Meeting Minutes Transmittal

Unit Managers' Meeting  
200-BP-11 Operable Unit and 216-B-3 Main Pond TSD Unit  
2440 Stevens Center Place, Room 2200  
Richland, Washington

TPA CHANGE REQUEST M-20-94-06

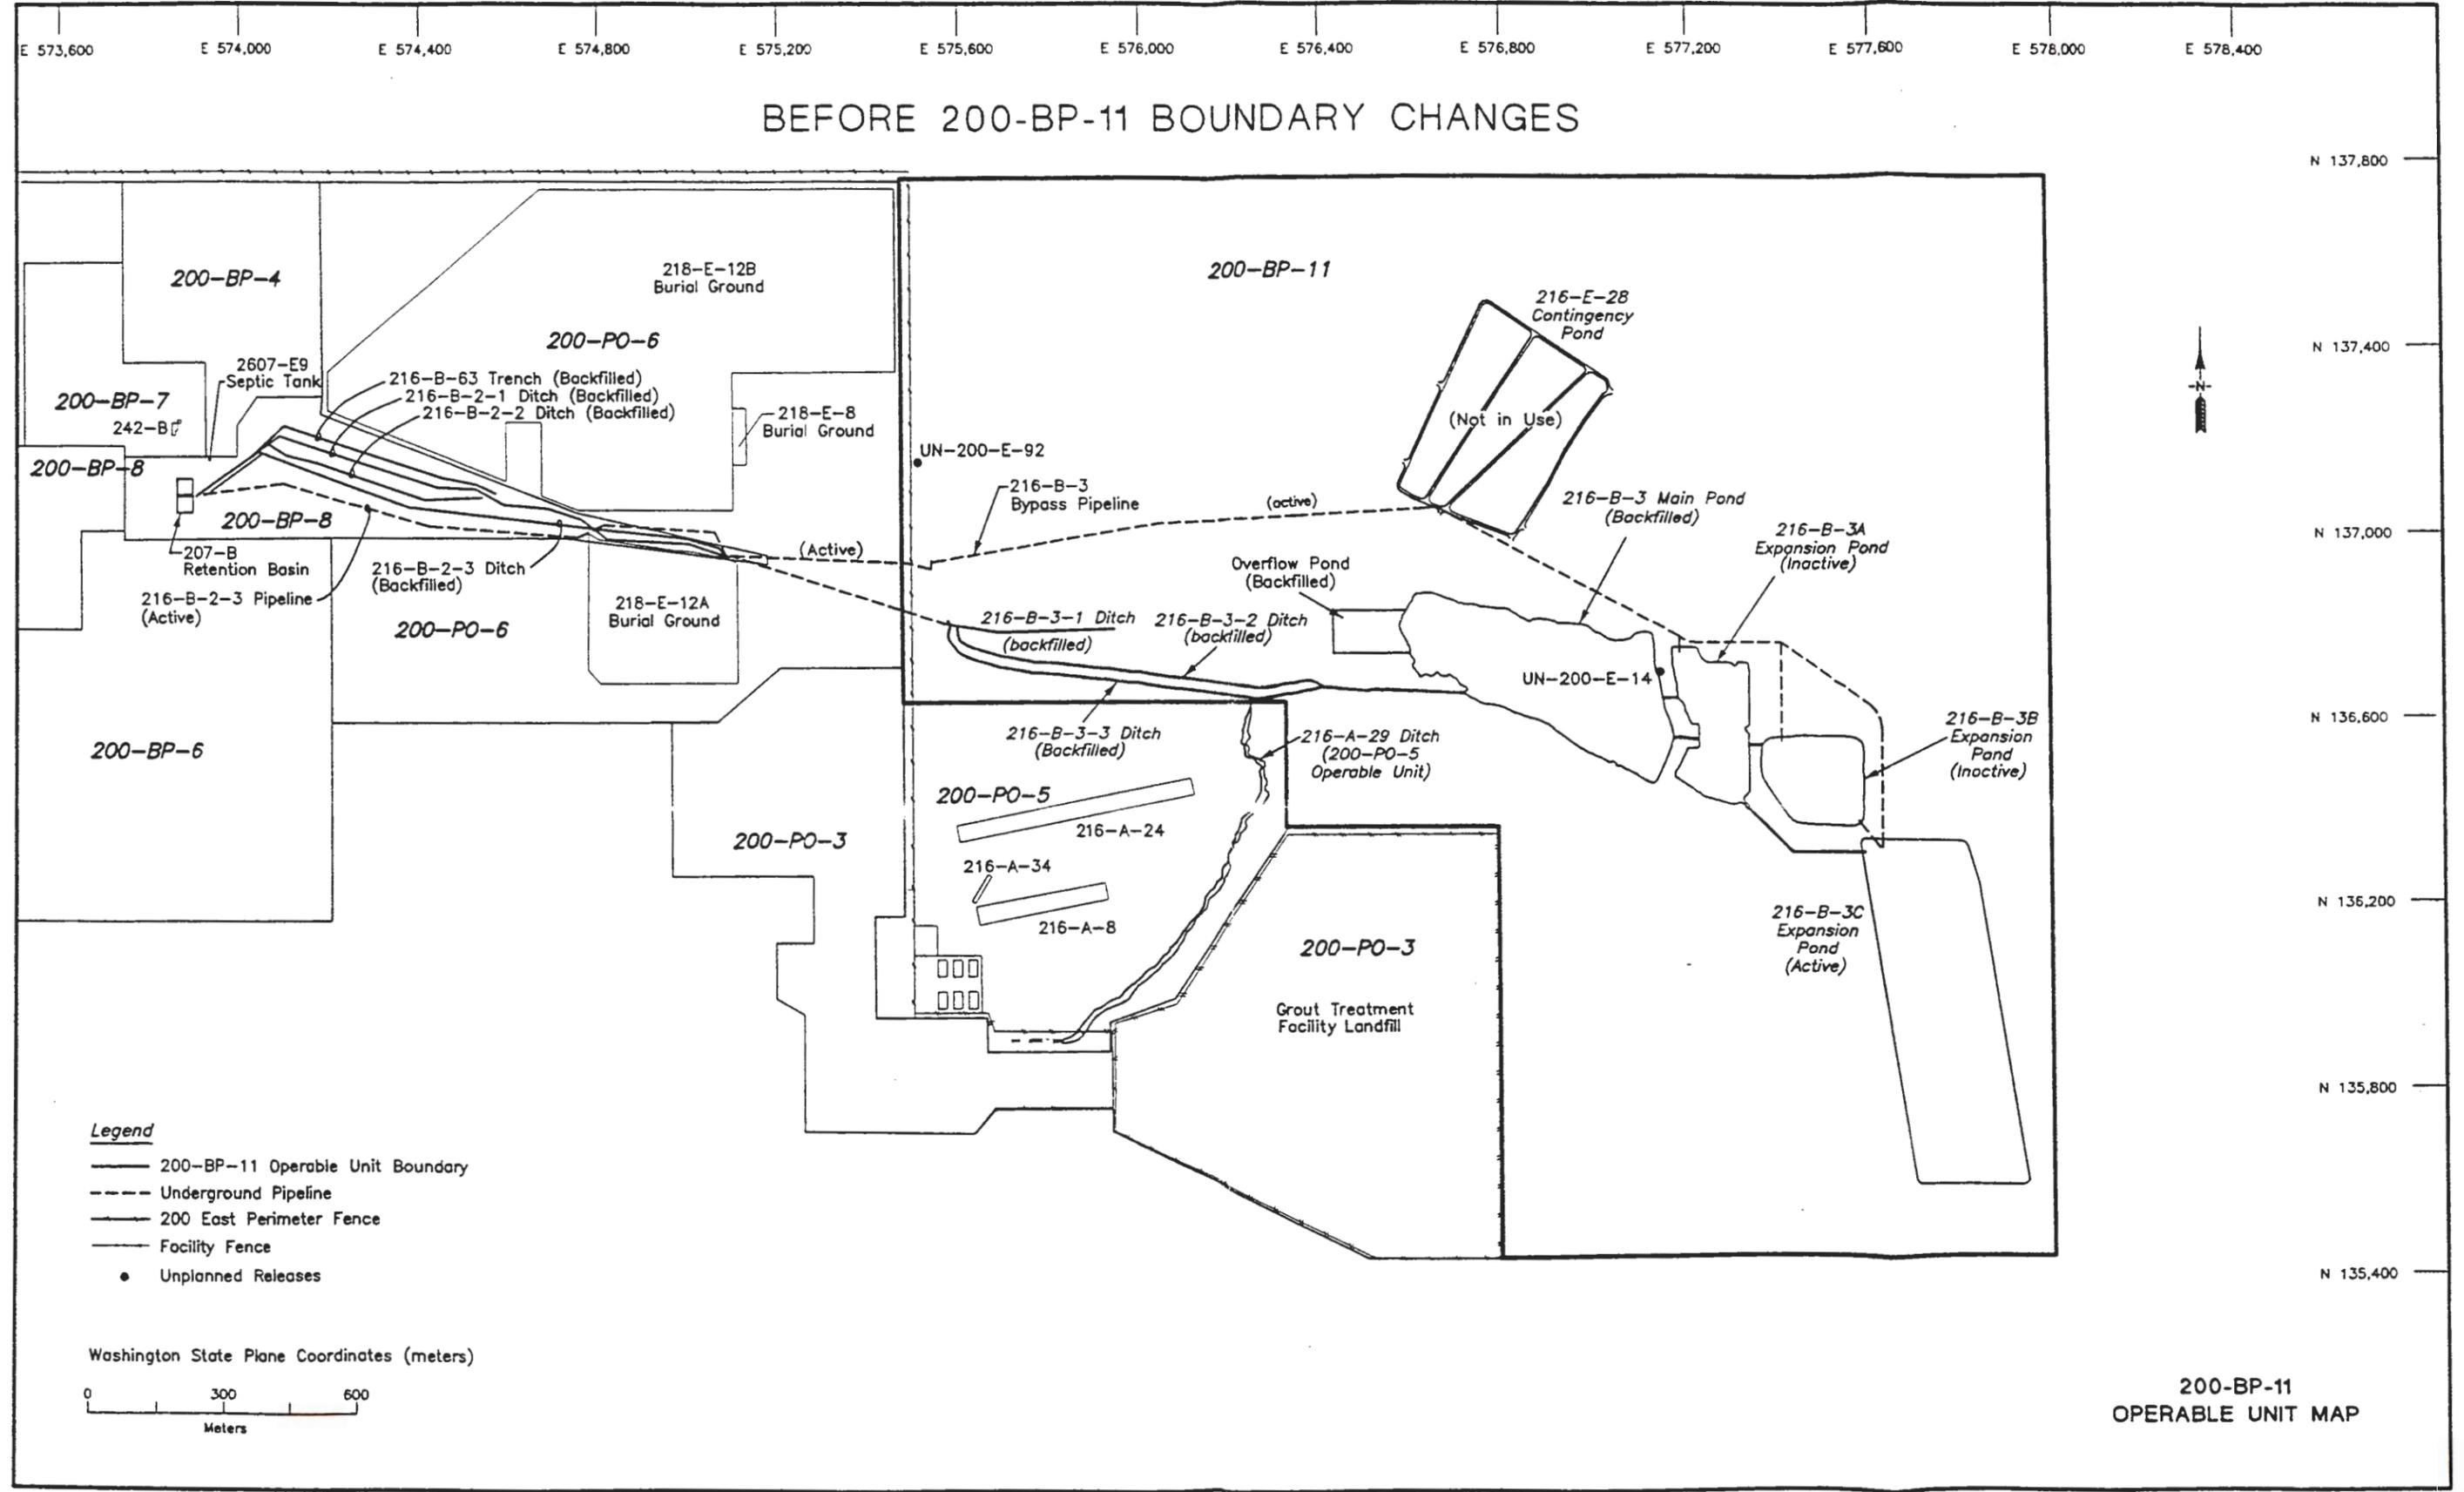
As shown on attached Figure 1, the 216-A-29 Ditch is currently located in the 200-PO-5 Operable Unit and the 216-B-63 Trench and 216-B-2-1, 216-B-2-2, and 216-B-2-3 Ditches are located in the 200-BP-8 Operable Unit. The 216-A-29 Ditch and 216-B-63 Trench are RCRA TSD units that are scheduled to have closure plans submitted to Ecology and EPA by May 1996 per TPA milestones M-20-36 and M-20-38, respectively. The 216-A-29 Ditch discharged to the 216-B-2-2 and 216-B-2-3 Ditches during its operational period. The 216-B-63 Trench did not discharge to other waste management units, however, it did received similar effluents as those received by the WMUs in the 200-BP-11 Operable Unit. The 216-B-2-1, 216-B-2-2, and 216-B-2-3 Ditches operated

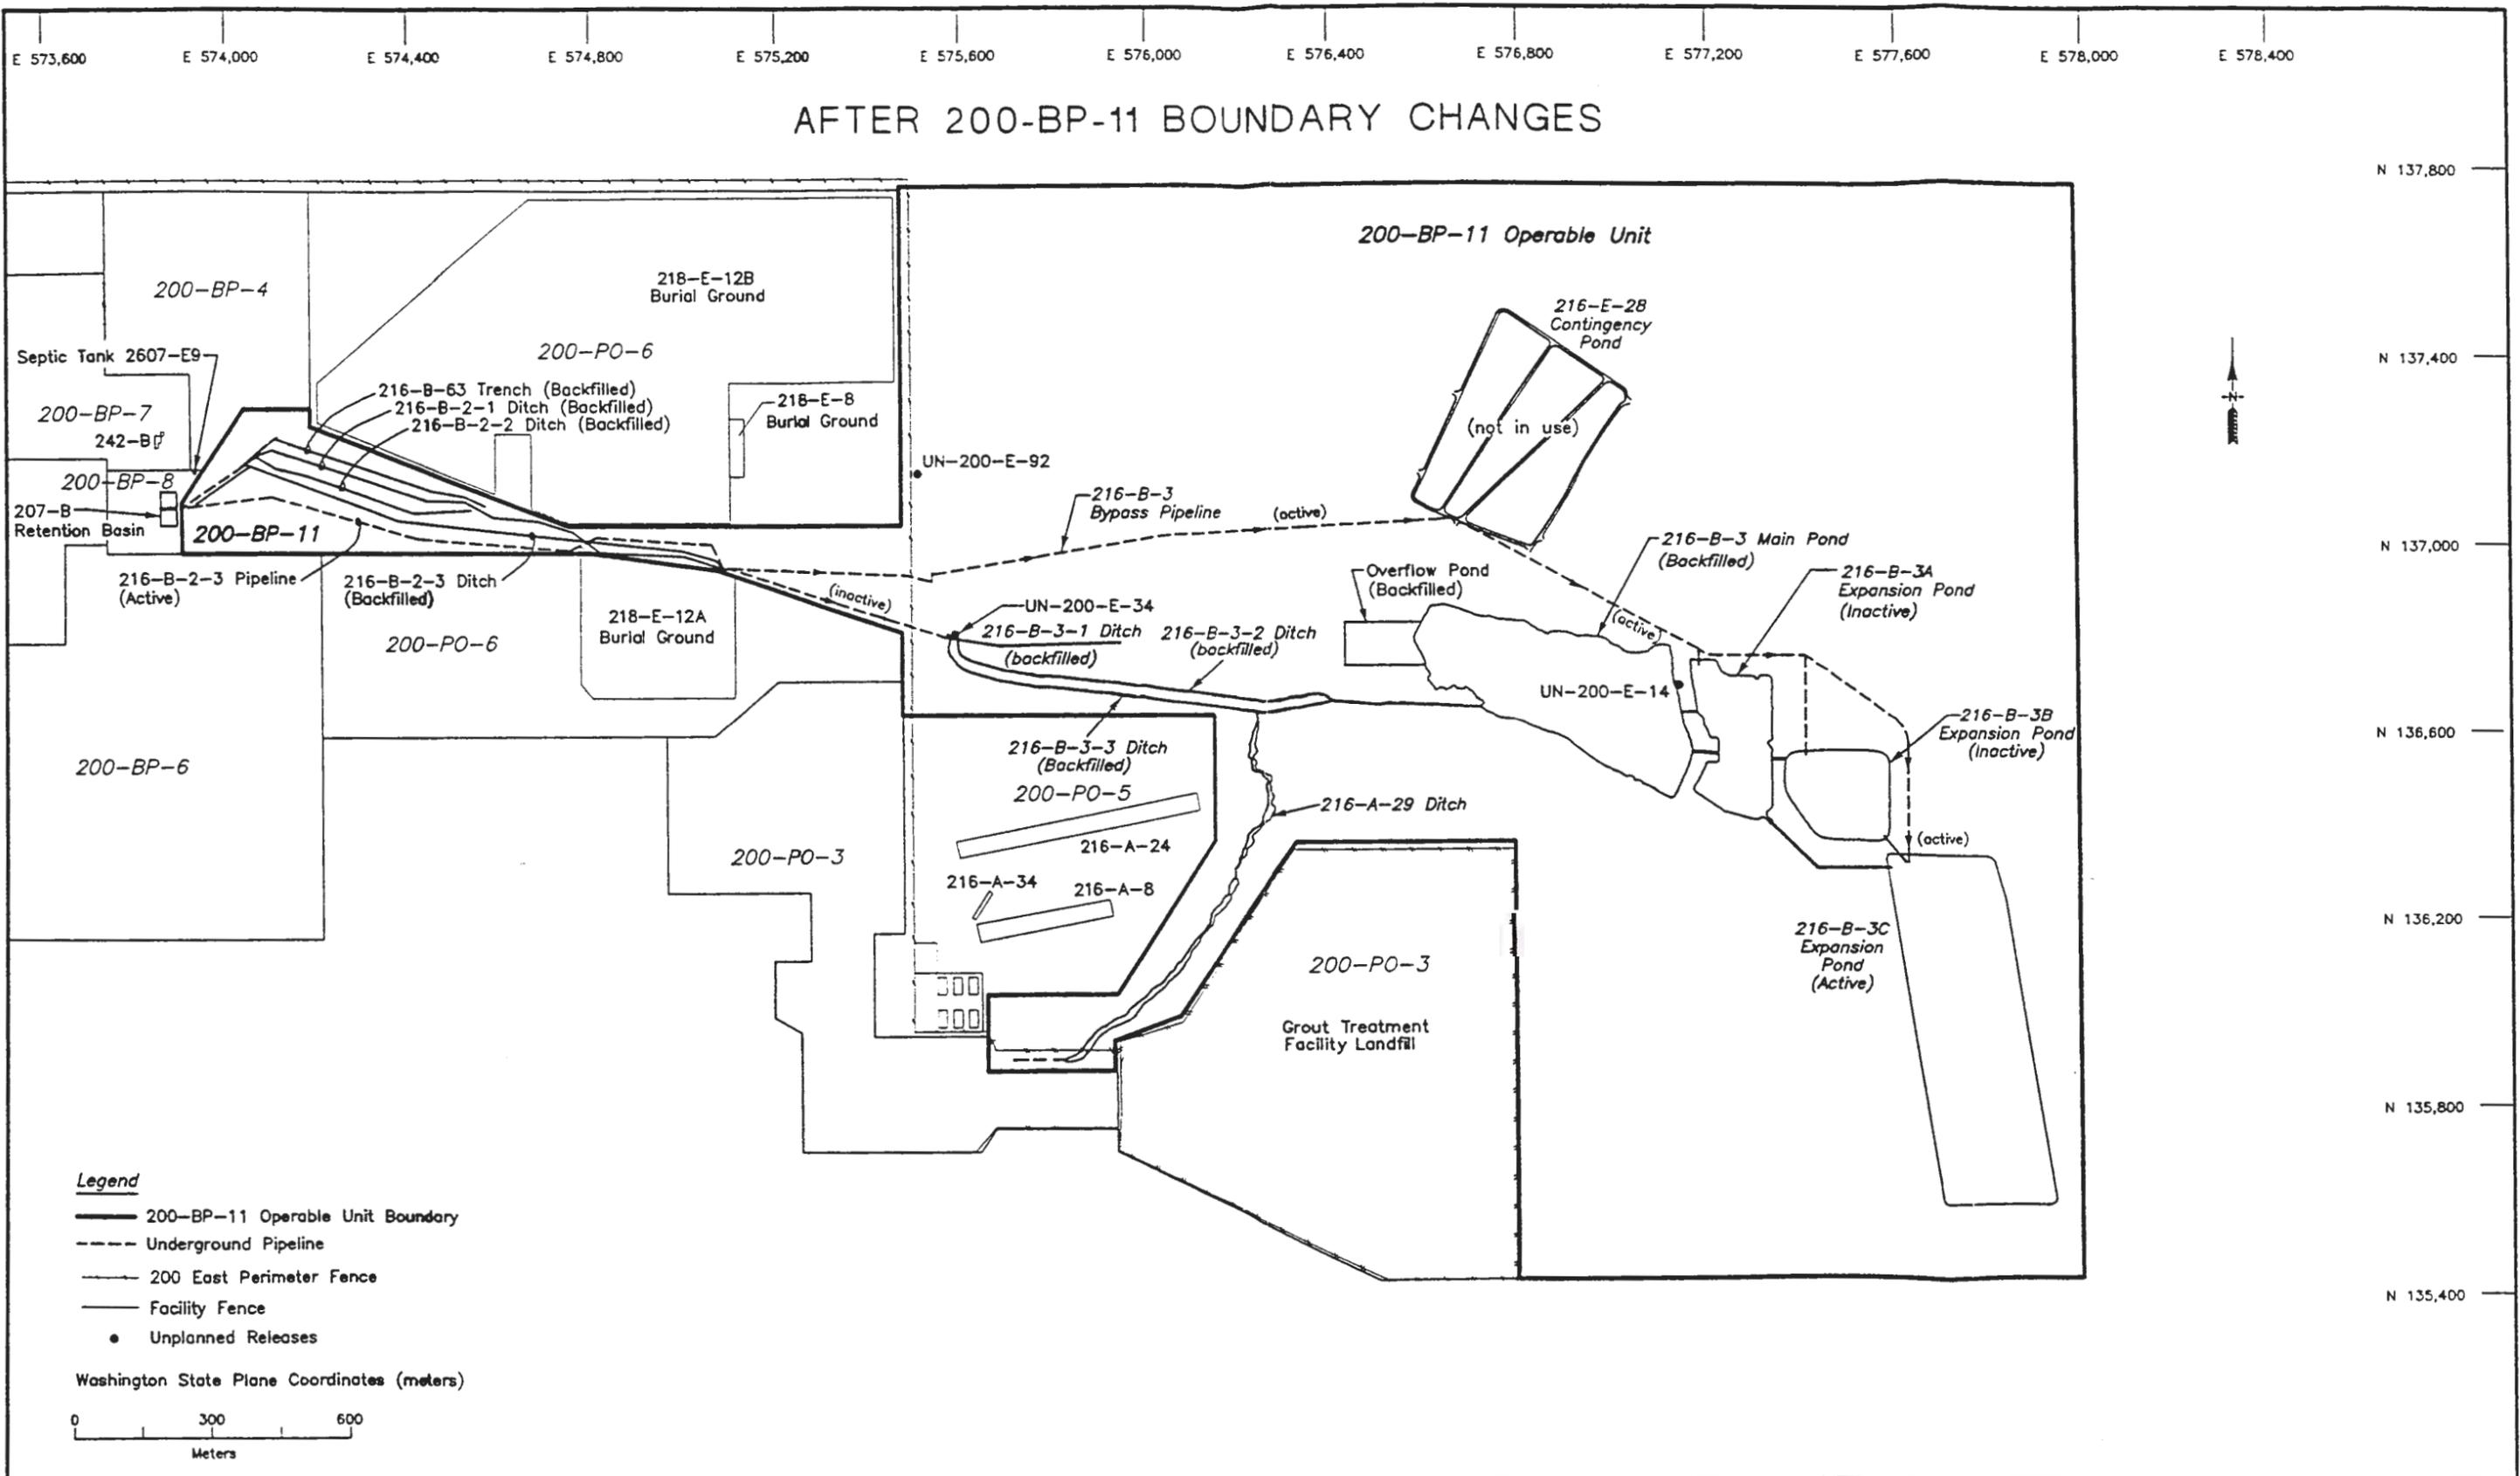
The attached Figure 2 depicts the new 200-BP-11 Operable Unit boundaries that will result from incorporation of the 216-A-29 Ditch, 216-B-63 Trench, and 216-B-2-1, 216-B-2-2, and 216-B-2-3 Ditches.
